Staff Report

Infill Housing Design Review

File Number: 9-C-25-IH

Description: After-the-fact revisions to 11-H-24-IH

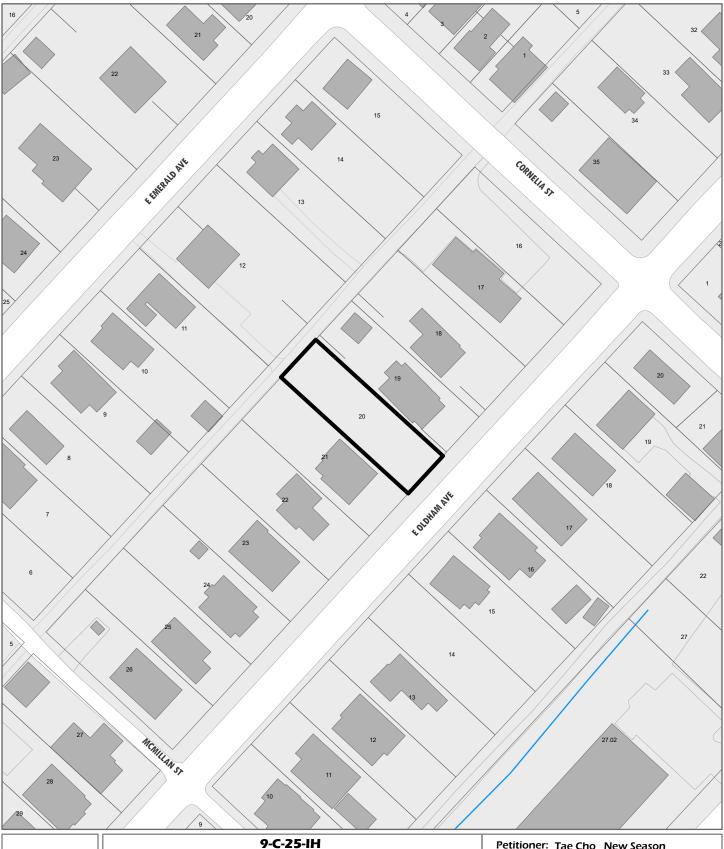
- 5. The design guidelines state that "porch posts and railings should be like those used in the historic era of the neighborhood's development" and that "porches should be proportional to original porches on the block." The height, form, and detail of the constructed front porches is incompatible with the historic houses on the block and

significantly increases the visual scale of the structure.

- 6. The footprint and design of the staircases should be revised to minimize its size. In the opinion of staff, the porches should be accessed via a central staircase where most of the height is concentrated that leads to a horizontal landing with a few steps that lead to the individual porches. Centralizing the staircase massing reflects the porches of the historic houses on the blockface and other houses in neighborhood with raised foundations to account for grade. The Board should discuss any alternative designs that would minimize the height and visual scale of the staircase.

Revised site plan

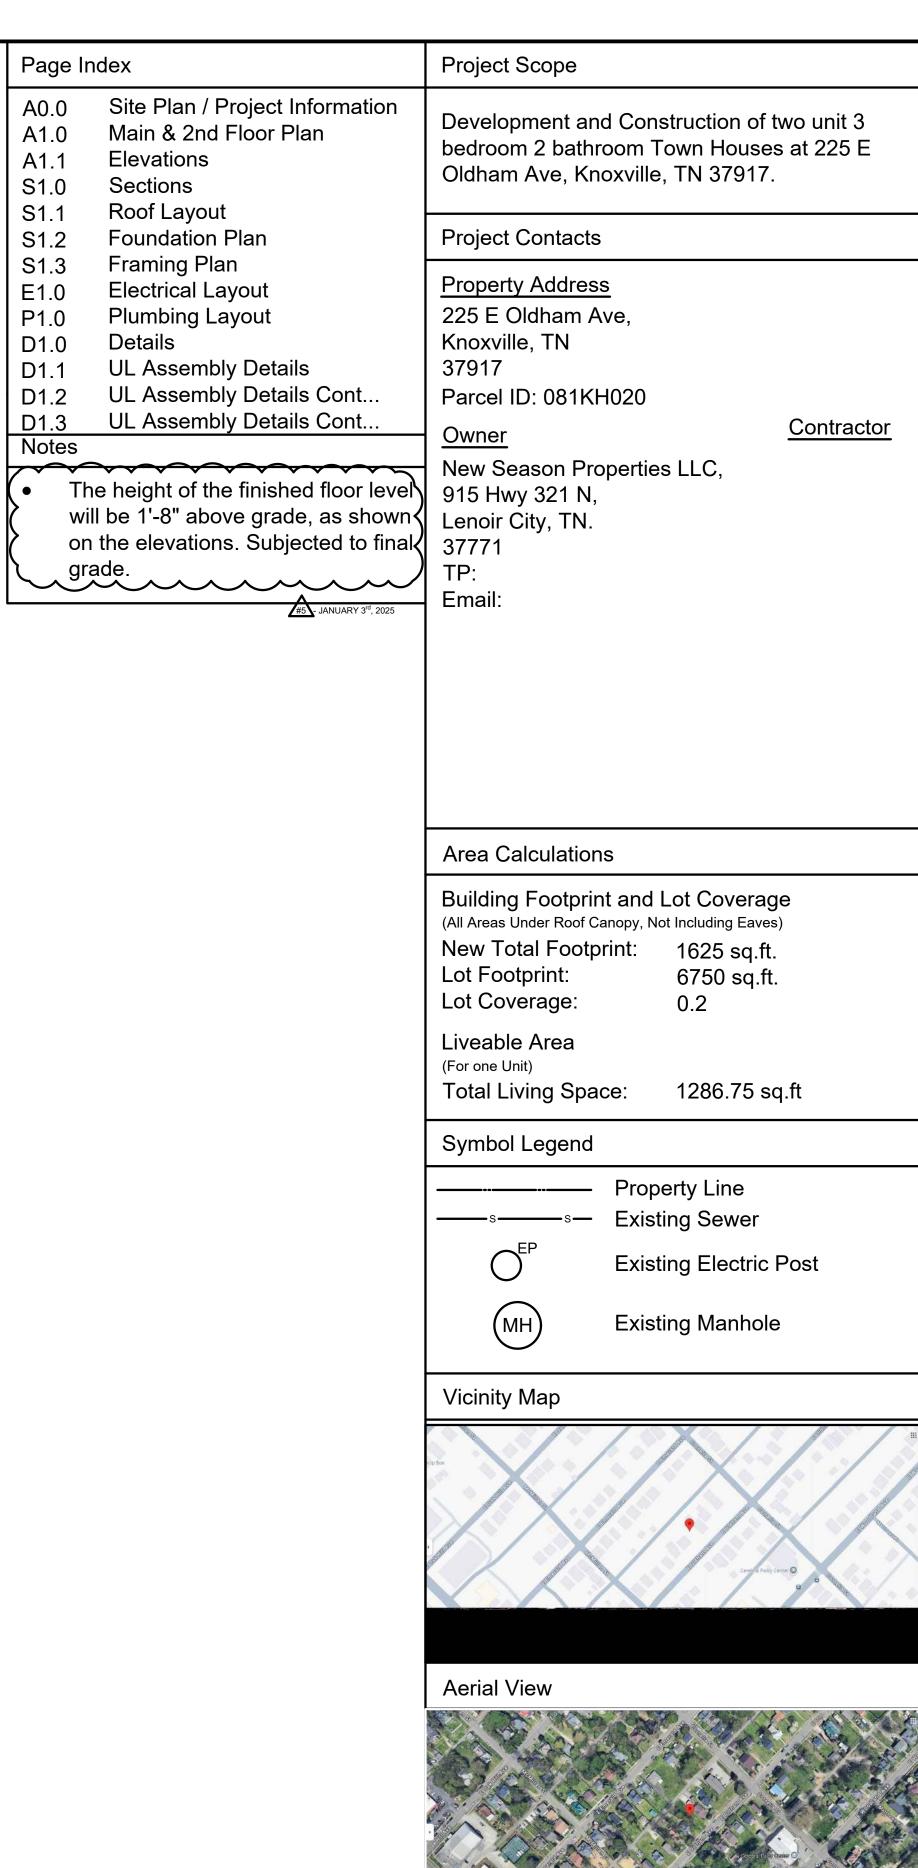
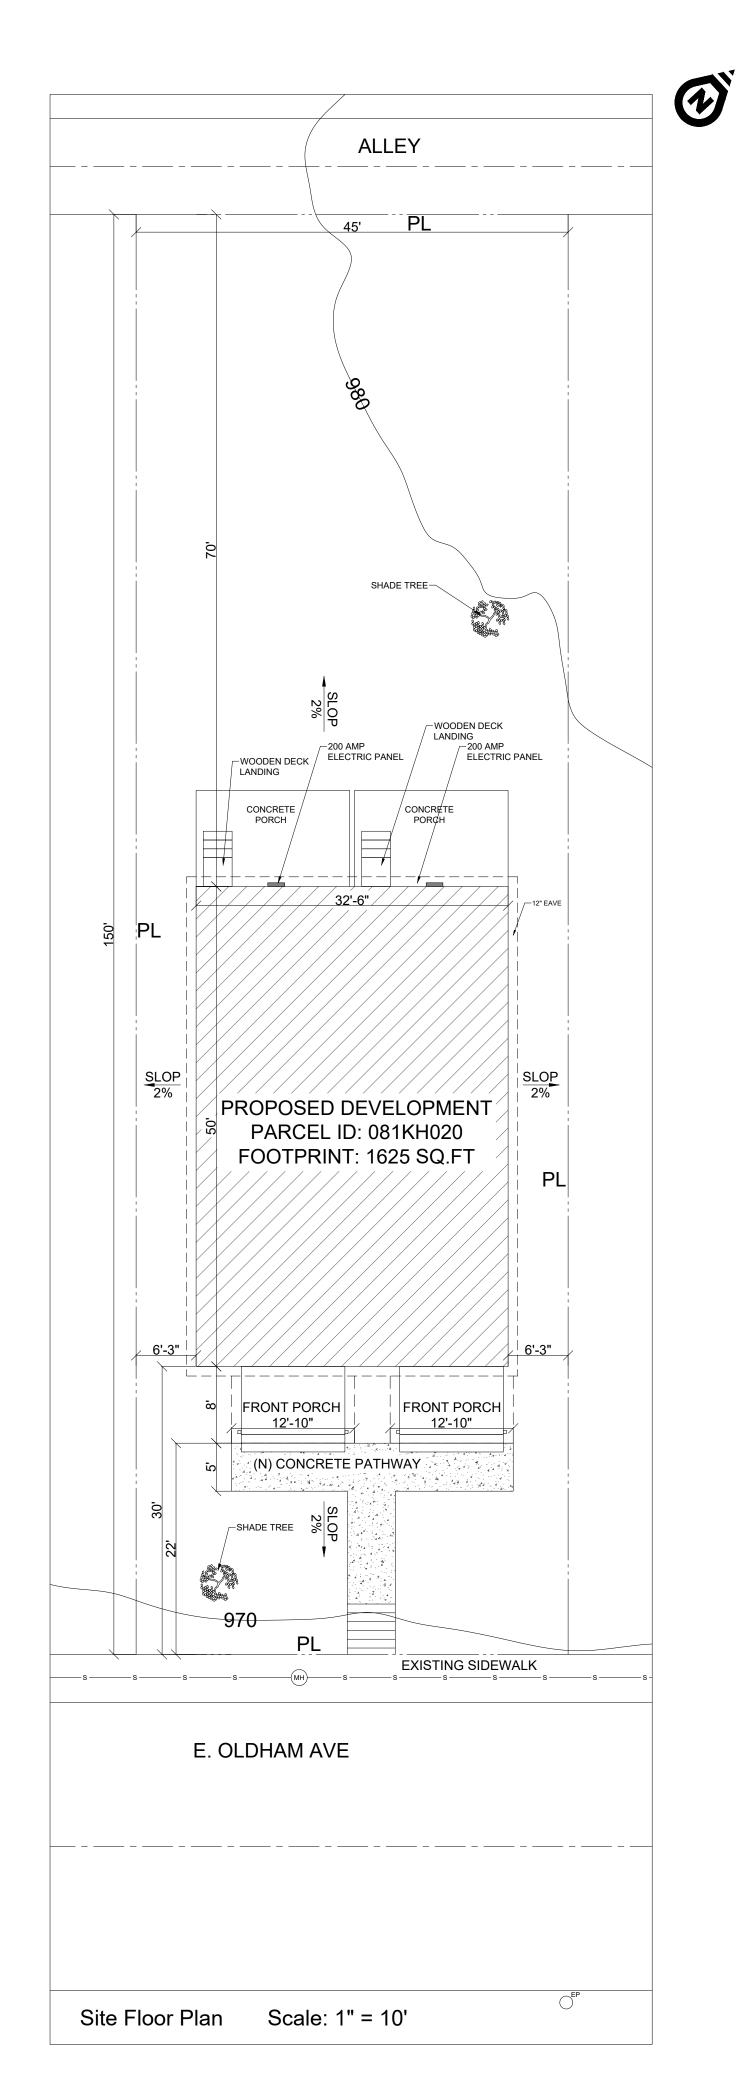
- 2. This is a Middle Housing project, and the approved plans did not include parking, as it is not required under Article 4.6.D. The proposed 40' wide by 35' deep gravel parking pad at the rear of the lot accessed via the alley meets the Infill Housing design guidelines and the Middle Housing standards, although it is large in scale. The Board should discuss the size of the proposed parking.
